# SONARtrac® Technical Bulletin

Subject: Installation of Sensor Bands

TB004 | Rev: 02

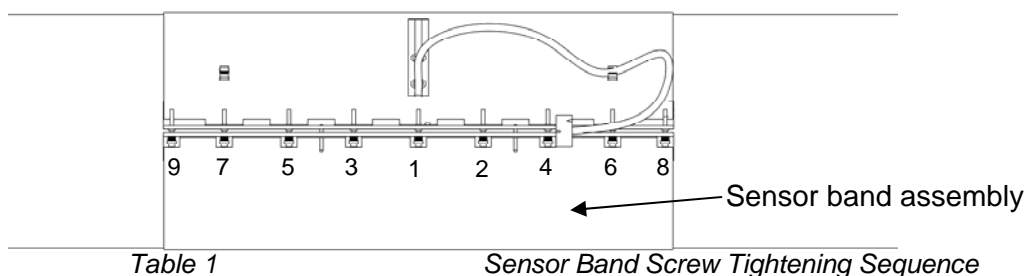
Technical Bulletin 004 was released on November 1, 2004 calling for additional tightening of the sensor screws. Since that time we have learned that we may be over-tightening the small size sensor bands (sizes 2 inch through 6 inch).

1. Install and tighten the sensor band screws in accordance with the procedure given in the Installation Manual. That is, tighten the screws a few turns at a time per the tightening sequence shown in Figure 1. Use the sensor band spacer tool to set the compression on the Bellville washers.

2. Starting at screw #1 in Figure 1, tighten screws #1 - #7 an additional one-half turn in the given numbered sequence. Do not tighten screws # 8 and 9.

1. Install and tighten the sensor band screws in accordance with the procedure given in the Installation Manual. That is, tighten the screws a few turns at a time per the tightening sequence shown in Figure 1. Use the sensor band spacer tool to set the compression on the Bellville washers.
2. Starting at screw #1 in Figure 1, tighten each screw one-half turn in the given numbered sequence.
3. Once all nine screws have been tightened, tighten each screw an additional one-half turn in the given numbered sequence.

4. Once all nine screws have been tightened a second time, tighten screws #1-7 an additional one-half turn in the given numbered sequence.
